V5_Civil CDs_comments.pdf Markup Summary

CARUBIA PROPERTIES - GRADING AND EROSION CONTROL SITE DEVELOPMENT CONSTRUCTION PLANS

CARUBIA PROPERTIES - PROPOSED DRAINAGE PLAN

GEC NOTES SHEET
CARUBIA PROPERTIES
LOT 2, BENT GRASS EAST COMMERCIAL FILING NO. 4
8059 MERIDIAN PARK DR
COUNTY OF EL PASO, COLORADO

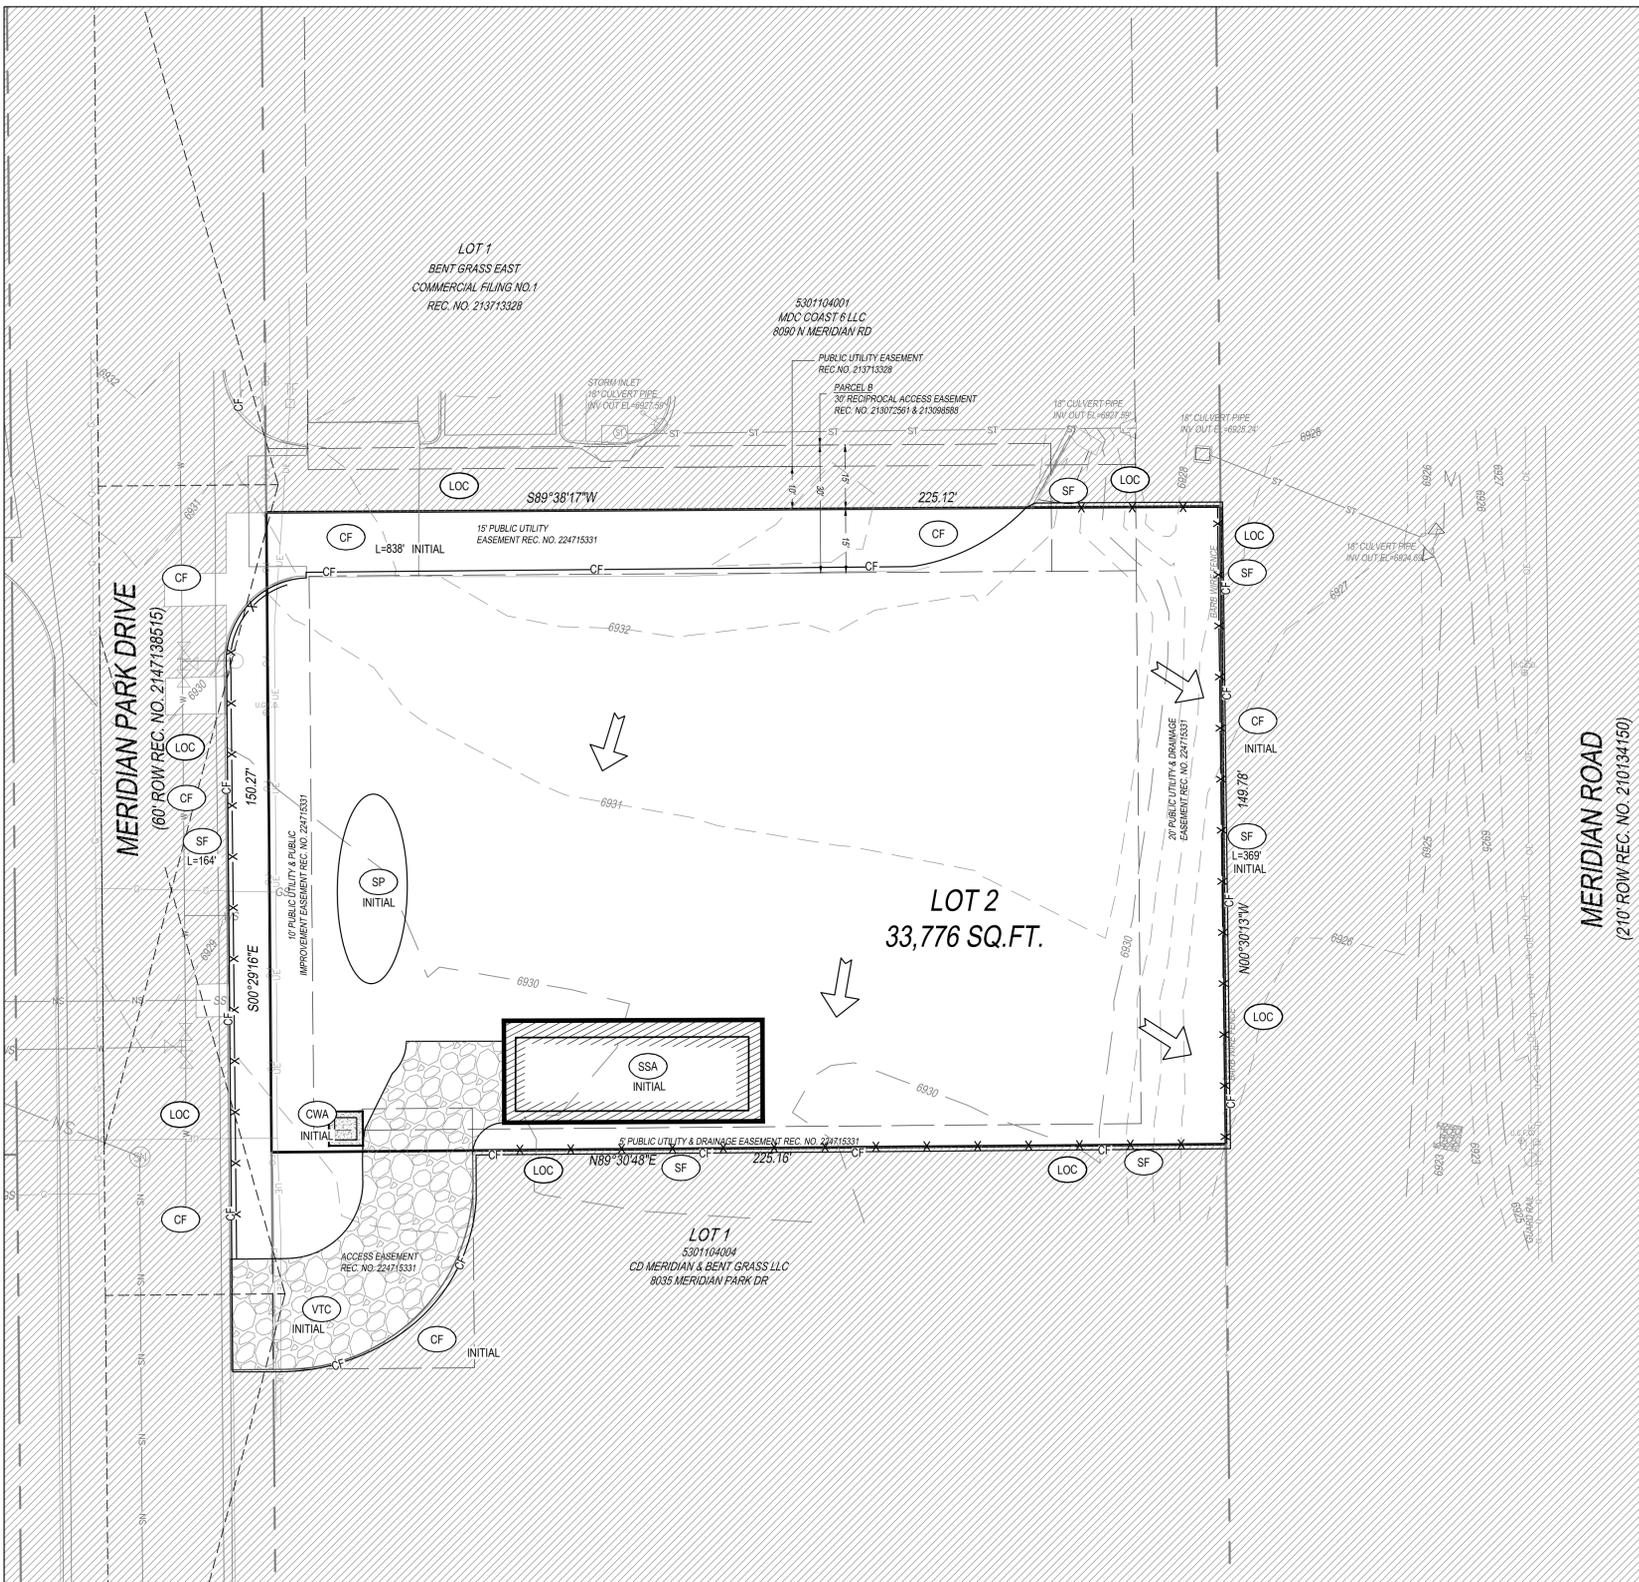
Revise notes as needed per my comments in the MHFD calcs in the Drainage Letter.

INTERIM GEC PLAN

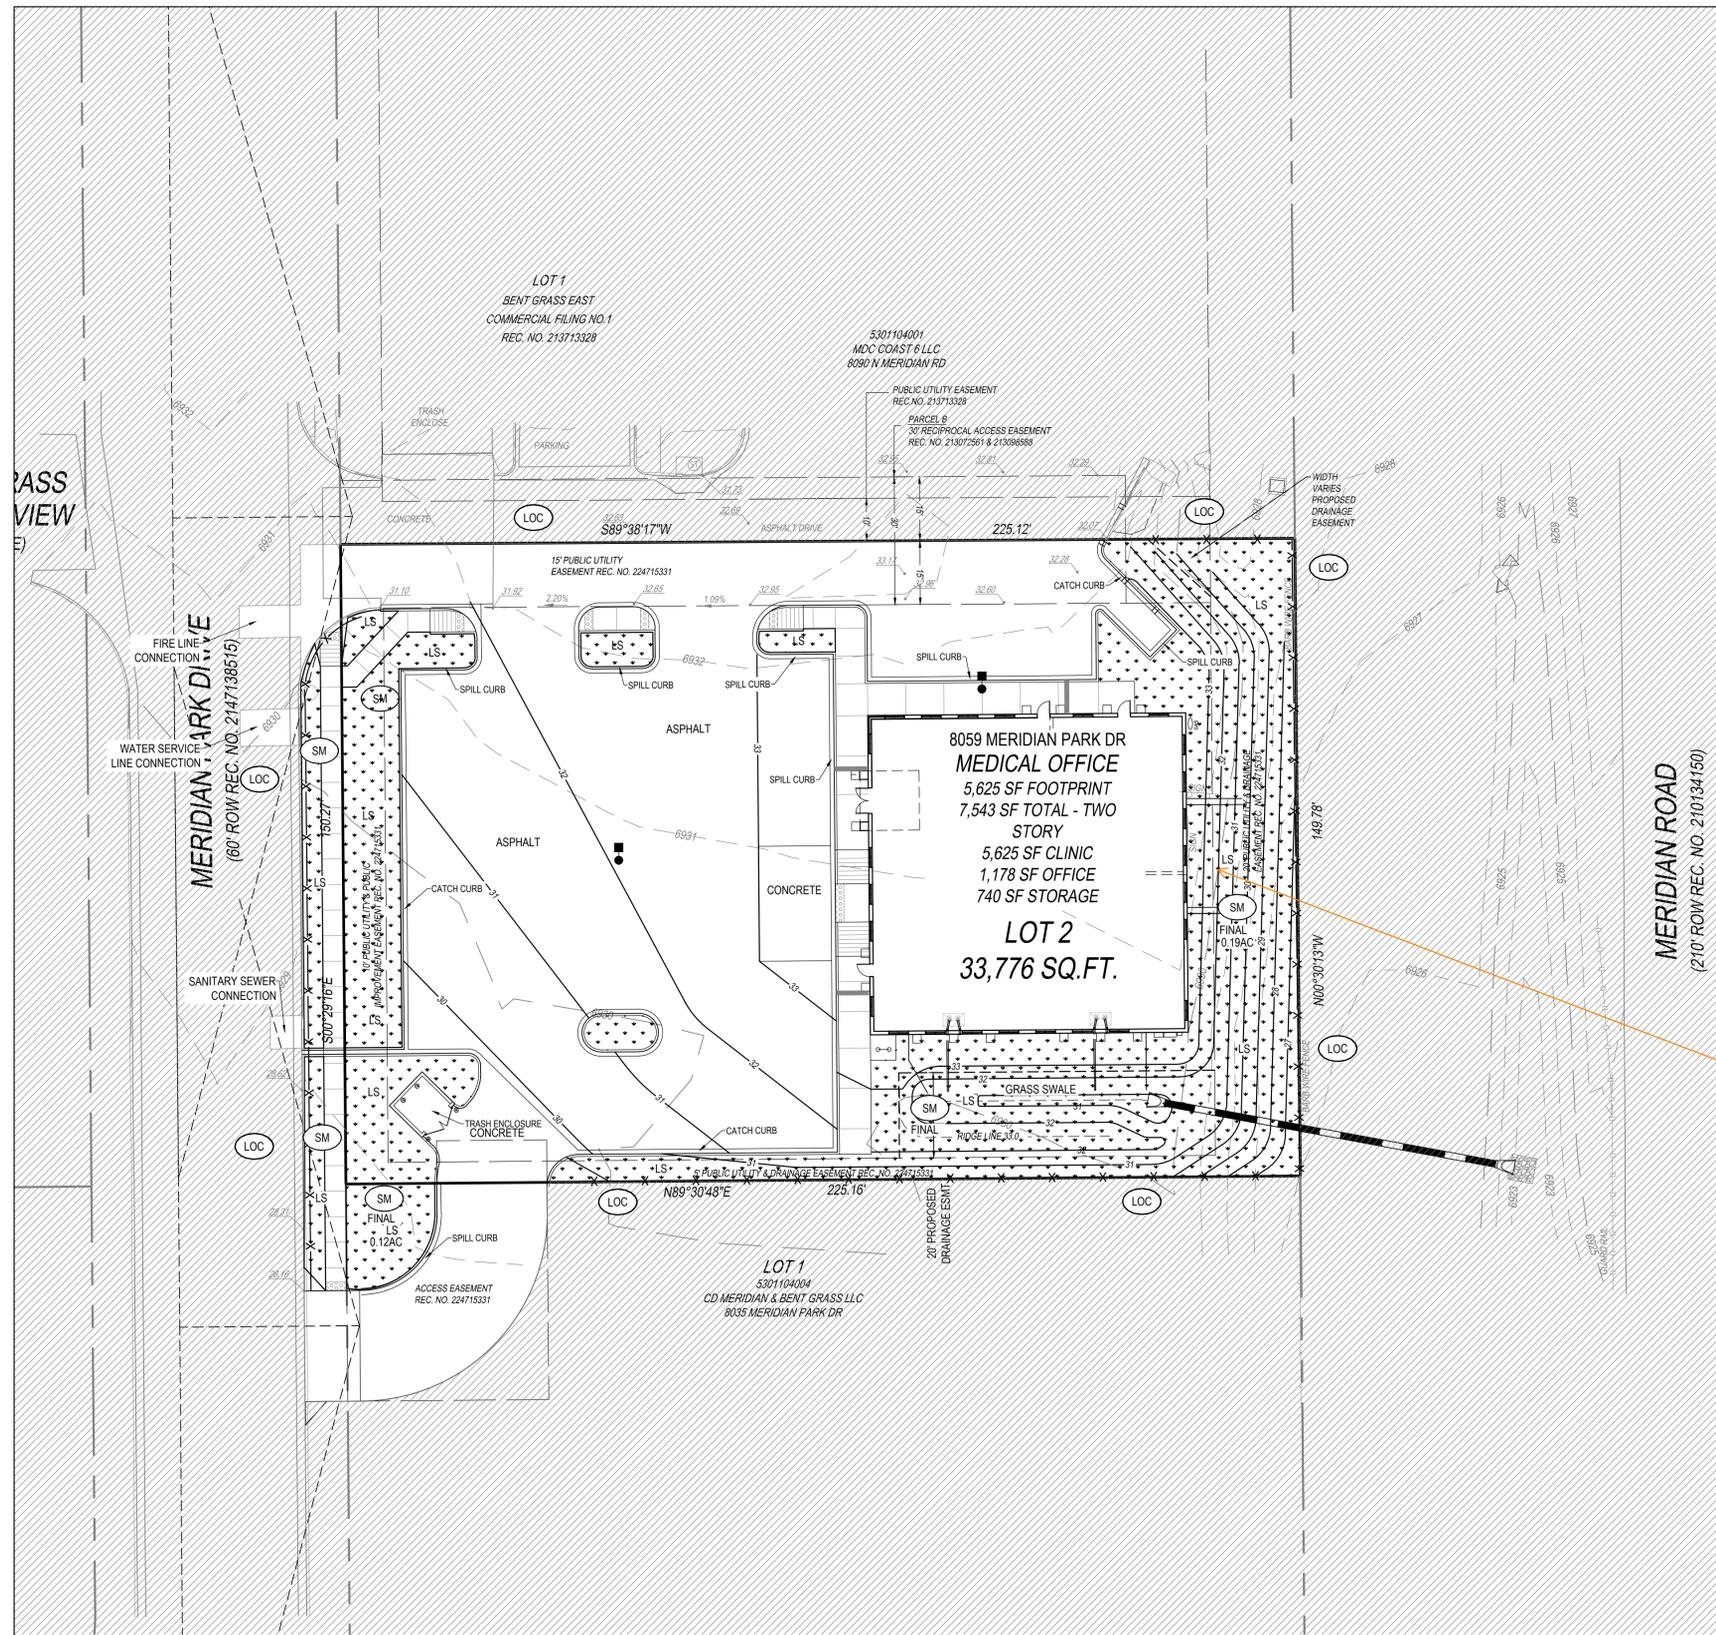
Per the blue shading on the next sheet, some of this area shown with SM hatching is actually rock. Please revise SM hatching and label/hatch as rock to account for this.

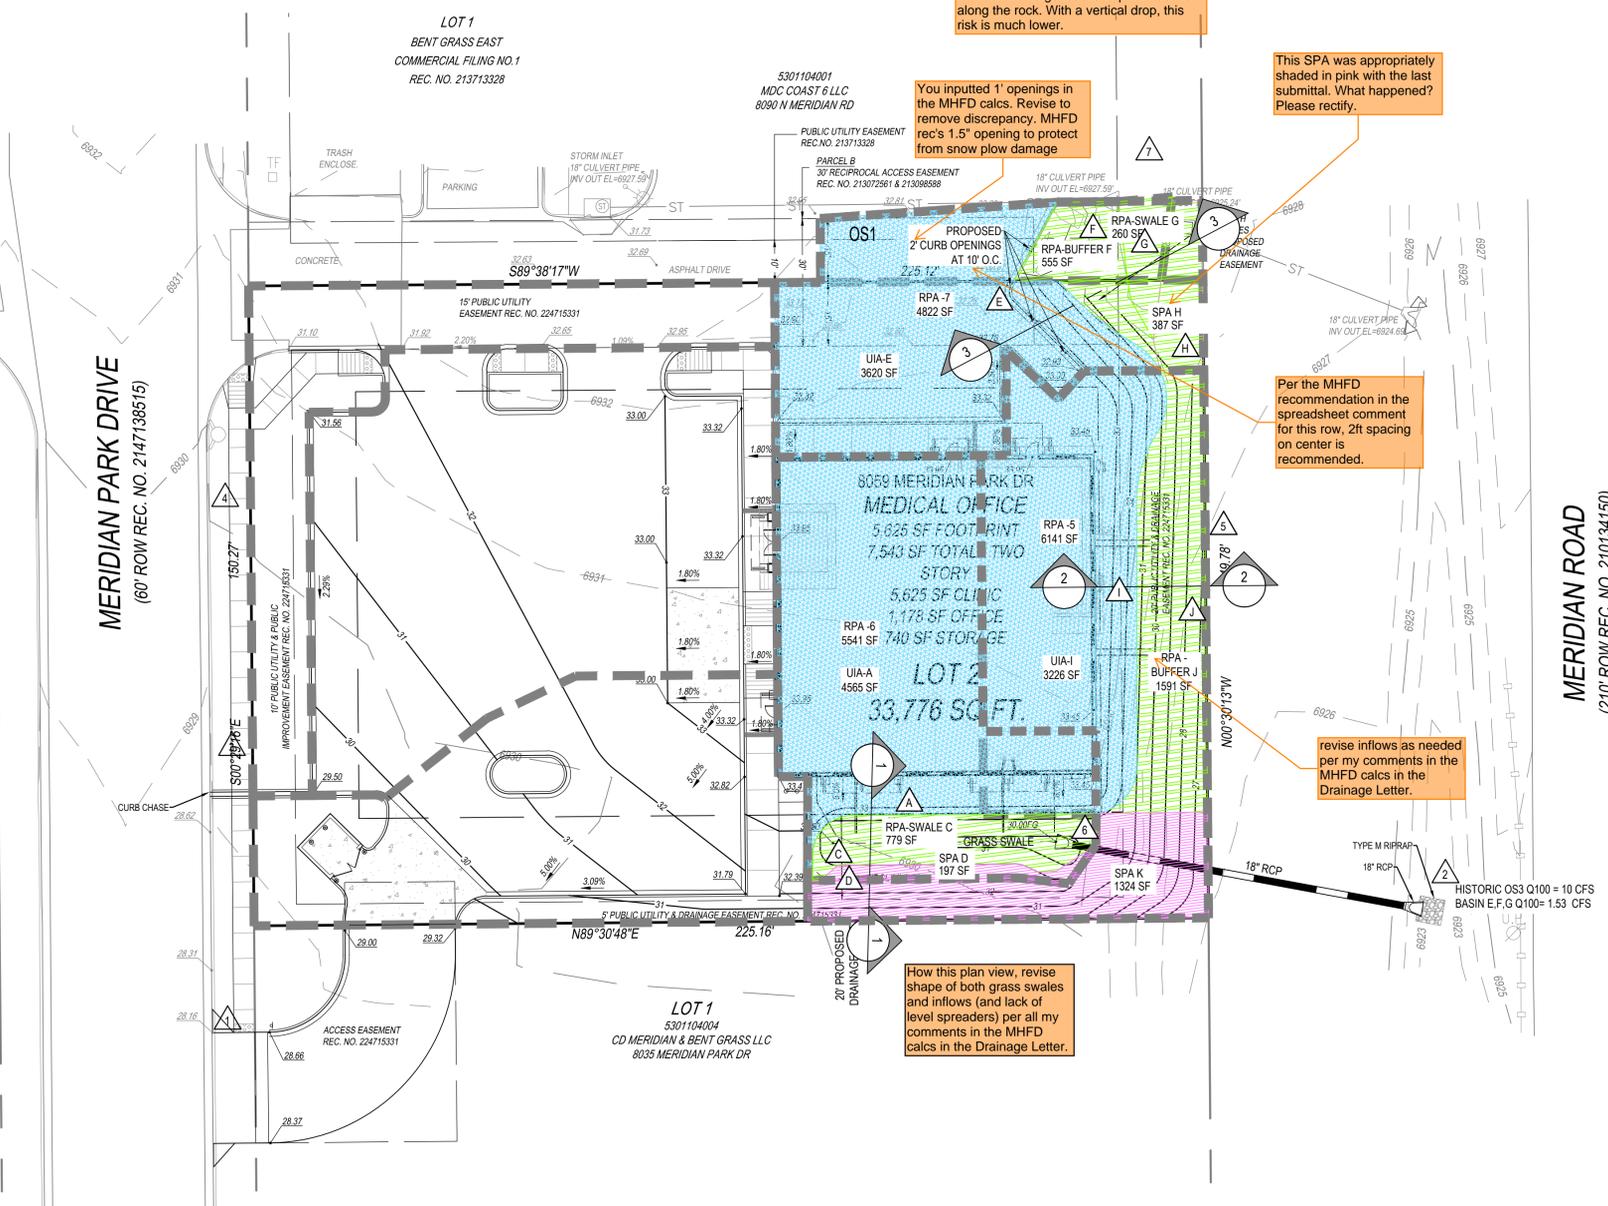
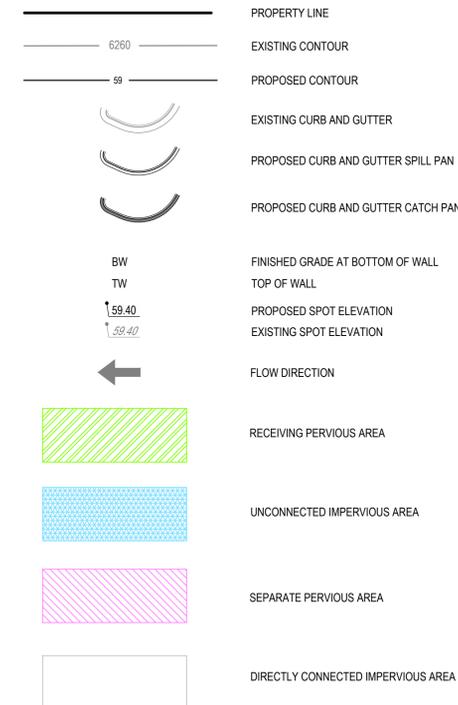
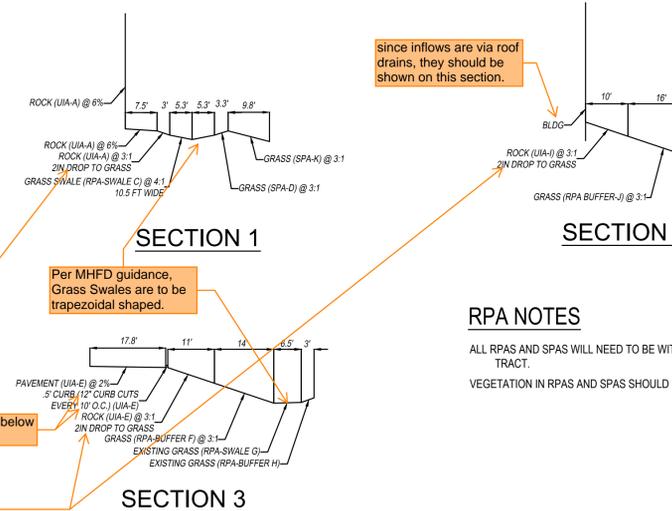
since inflows are via roof drains, they should be shown on this section.

This SPA was appropriately shaded in pink with the last submittal. What happened? Please rectify.

You inputted 1' openings in the MHFD calcs. Revise to remove discrepancy. MHFD rec's 1.5" opening to protect from snow plow damage

Per the MHFD recommendation in the spreadsheet comment for this row, 2ft spacing on center is recommended.

revise inflows as needed per my comments in the Drainage Letter.
